REF: 040527 NUB 3CAP0207
Sewage Spill Follow-up - 1 TAE

Re: Cape Dorset Lagoon/ Sewage Spill Follow up, May 5, 2004

Figure 2. The second and third cells of the Cape Dorset Sewage Lagoon with the second cell full to overflowing.

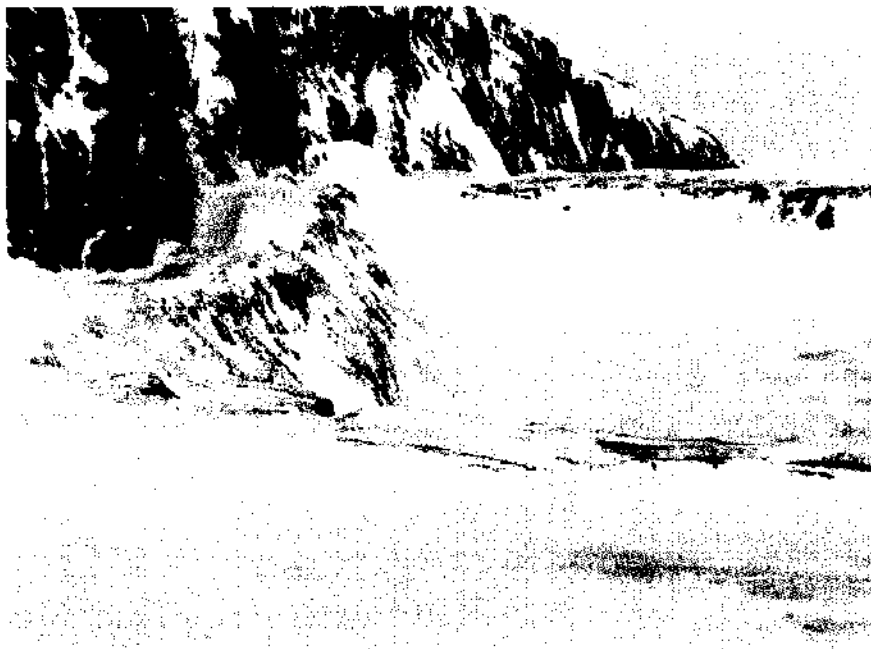
that the 3-celled lagoon is in imminent danger of overflowing and washing out as soon as the spring melt begins. The first cell is close to the level of the overflow culvert (Figure 1) while the second cell is full above the overflow culvert and has surpassed the surface of the berm in one area (Figure 2 and Figure 3). The sewage that has overflowed from cell one is flowing along the diversion channel on the mountain side of cell two. This overflow from cell one has produced a large build up of ice that is moving down the side of cell two (Figure 4). It appears that this sewage shall both erode the side of cell two and possibly flow along the mountain side, by-passing the third cell entirely. The situation could potentially result in a catastrophic failure of cells two and three of the lagoon.
